Errata to MPC8544E PowerQUICC™ III Integrated Host Processor Family Reference Manual, Rev. 1

This errata describes corrections to the *MPC8544E PowerQUICC™ III Integrated Host Processor Family Reference Manual*, Revision 1. For convenience, the section number and page number of the errata item in the reference manual are provided. Items in bold are new since the last revision of this document.

Figure 18-176. PCI Express Error Classification

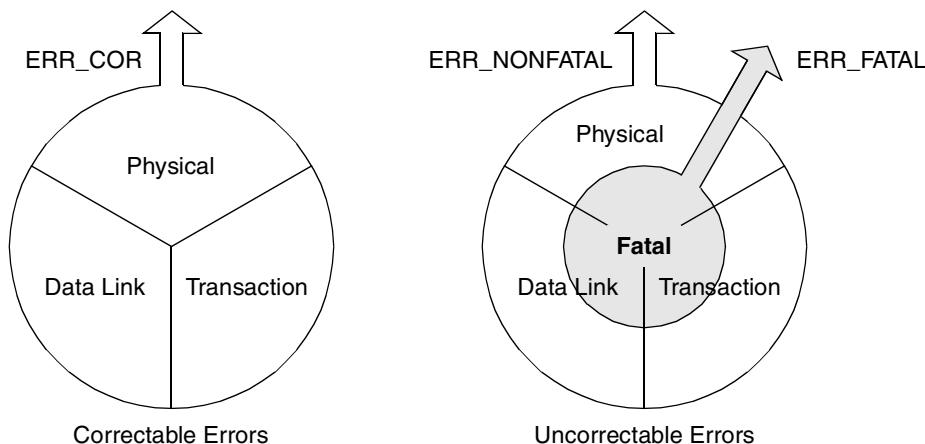
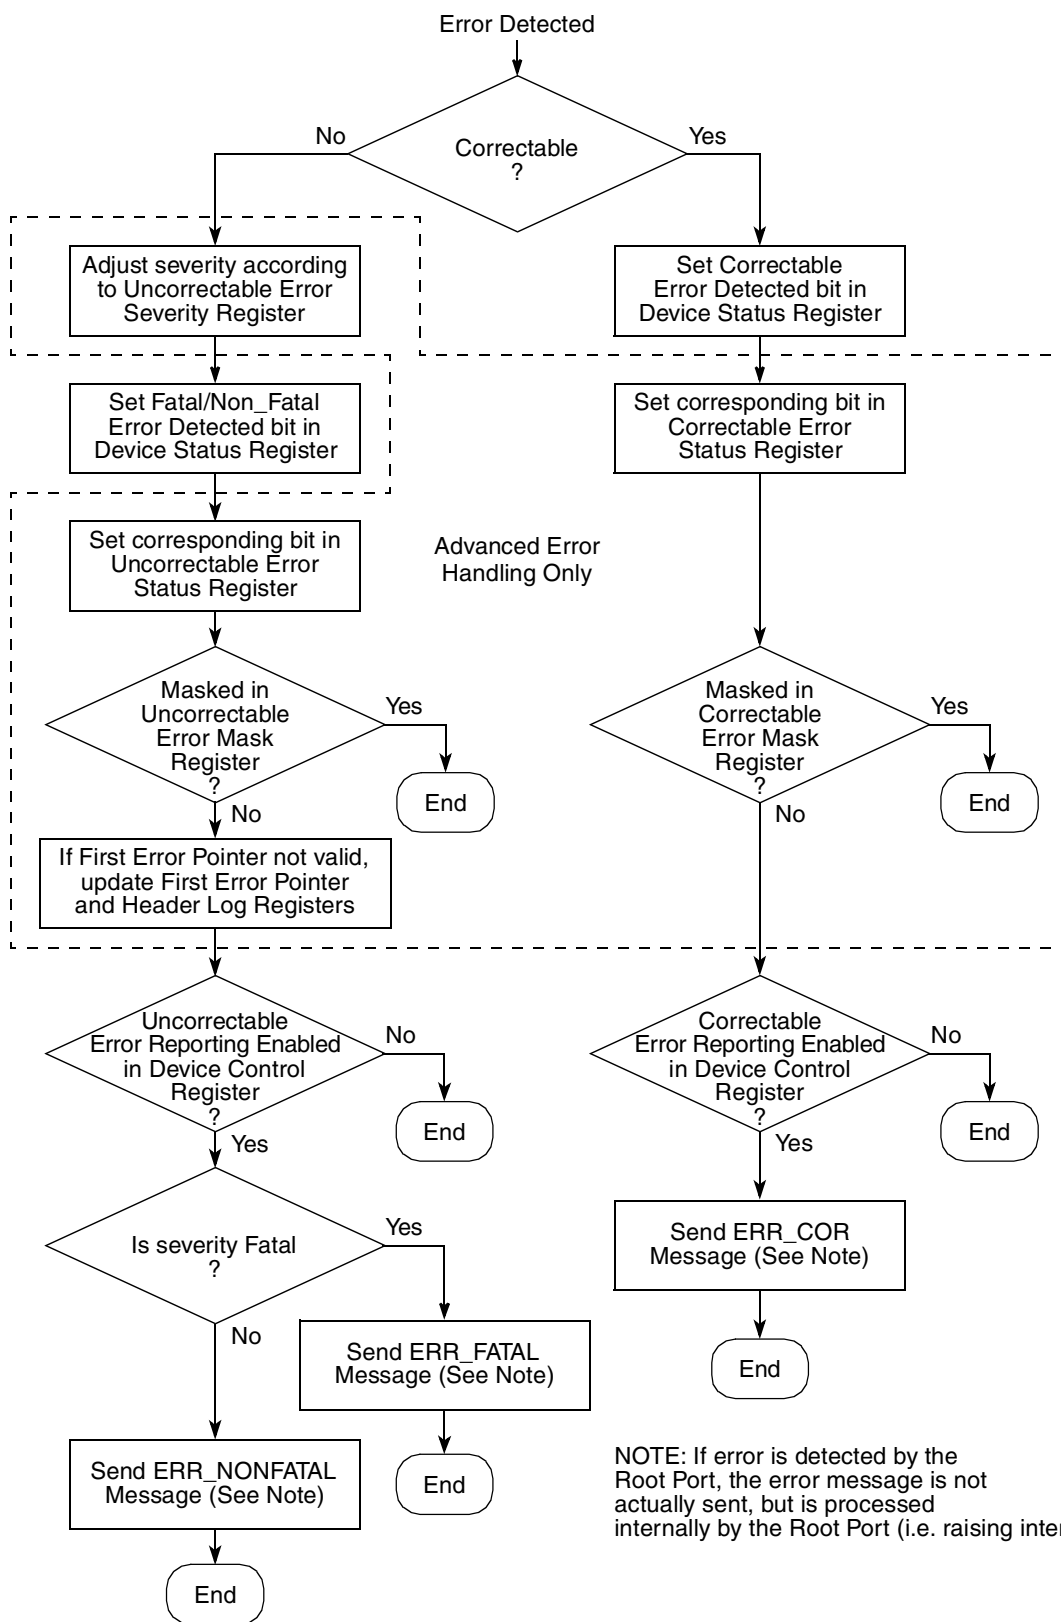
Modified the section to say the following:

18.4.1.10 Error Handling

The PCI Express specification classifies errors as correctable and uncorrectable. Correctable errors result in degraded performance, but uncorrectable errors generally result in functional failures. As shown in Figure 18-176, uncorrectable errors can further be classified as fatal or non-fatal.

Figure 19-12. Device Disable Register (DEVDISR)

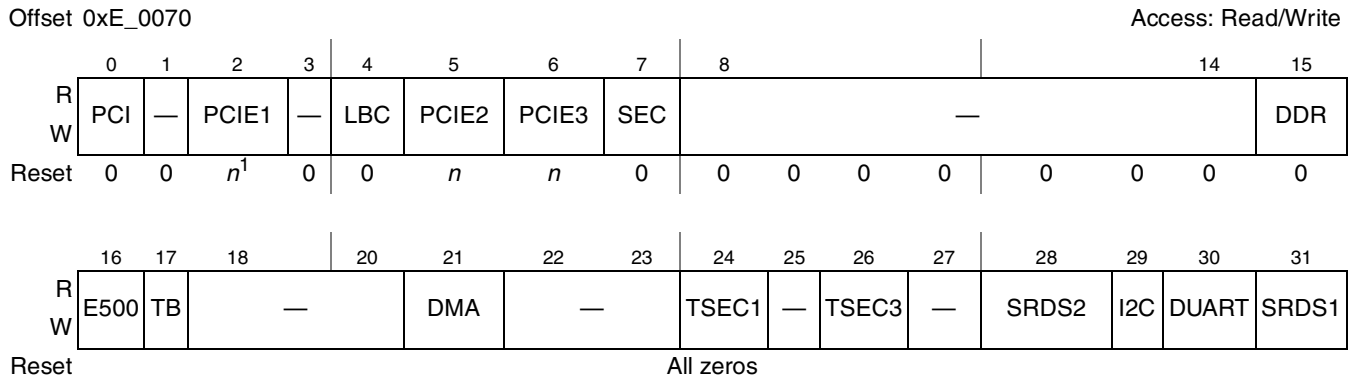
19.4.1.12, 19-14 Added fields SRDS2 and SRDS1 (bits 28 and 31) to Figure 19-12, “Device Disable Register (DEVDISR)” and Table 9-15, “DEVDISR Field Descriptions.” The register figure and field description table changes should appear as follows:
